Keystone RV Company

SAFETY ADVISORY # 22-431

Zinger Furnace Exhaust Vent

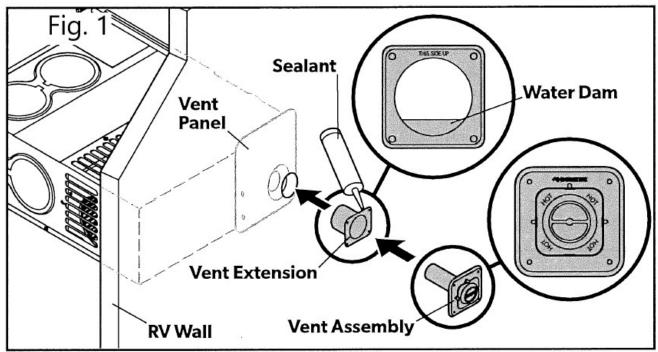
Remove the exterior metal exhaust (four screws). See Figure 1.

Inspect for the plastic exterior vent panel. See Fig 1. If the plastic exterior vent extension is installed proceed to warranty reimbursement. If not proceed to step 4.

Install the plastic exterior vent extension KRV # 637124 - Furnace - Vent Panel - Exterior. Seal as indicated in Figure 1.

Reinstall the exterior metal vent. Top seal only, top of vent and both sides. Proceed to warranty reimbursement.
